UNITED STATES PATENT AND TRADEMARK OFFICE

| APPLICATION NO. | FILING DATE | FIRST NAMED INV | ENTOR | ATTORNEY DOCKET NO. | CONFIRMATION NO. |
|---|-----------------|-----------------|----------|---------------------|------------------|
| 10/706,945 | 11/14/2003 | Yoshihiro Fuk | ano | CS-31-031114 | 7414 |

DETAILED ACTION

FIG. 4(a)

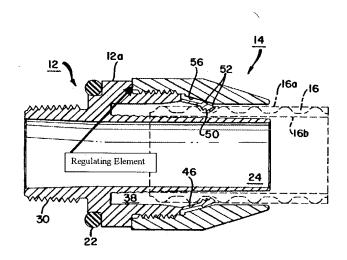
a regulating element (see Figure 4a below) which is provided on an end face of the nut member to be screwed on the joint body and which regulates a screwing amount of the nut member on the joint body.
